Project : BROWNSVILLE SHIP CHANNEL, TEXAS

UNCONFINED COMPRESSION TEST REPORT

SUMMARY OF QUESTIONABLE
ERRONEOUS OR MISSING DATA
FOR
CONTRACT NO. DACW64-90-C-0024
PROJECT: LABORATORY TESTING OF SOIL SAMPLES, BROWNSVILLE SHIP CHANNEL, TEXAS

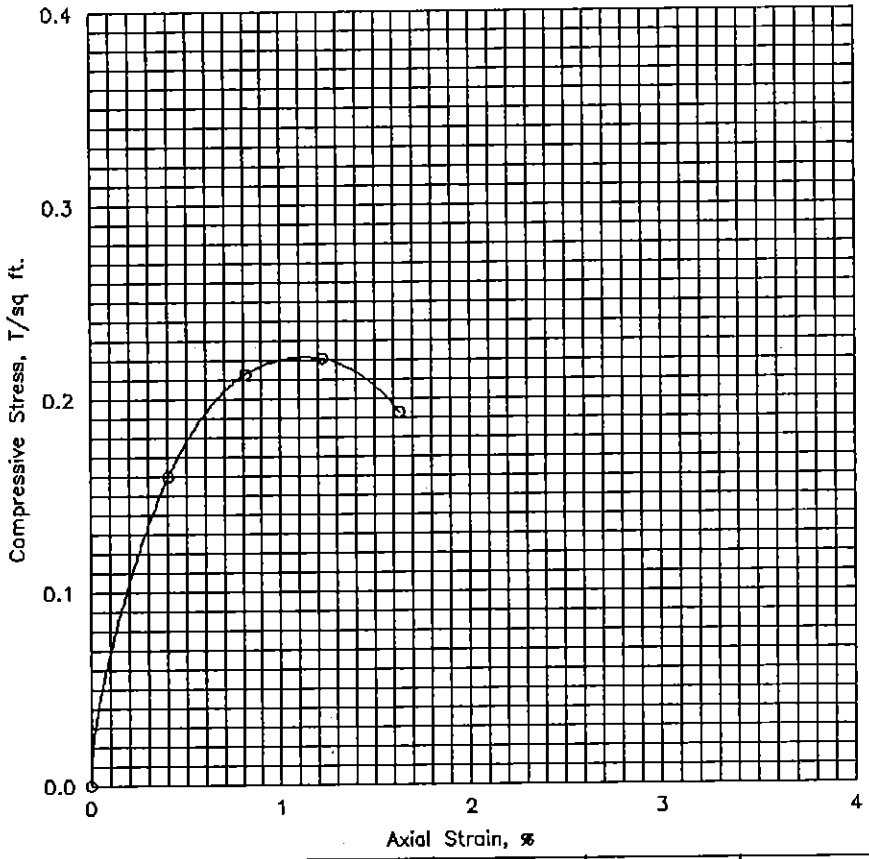
89-56	3	Moisture-density relationship as derived from moisture content and unit dry weight tests appears low. Unconfined compression test results appears low.
	5	Unit dry weight test result appears erroneous.
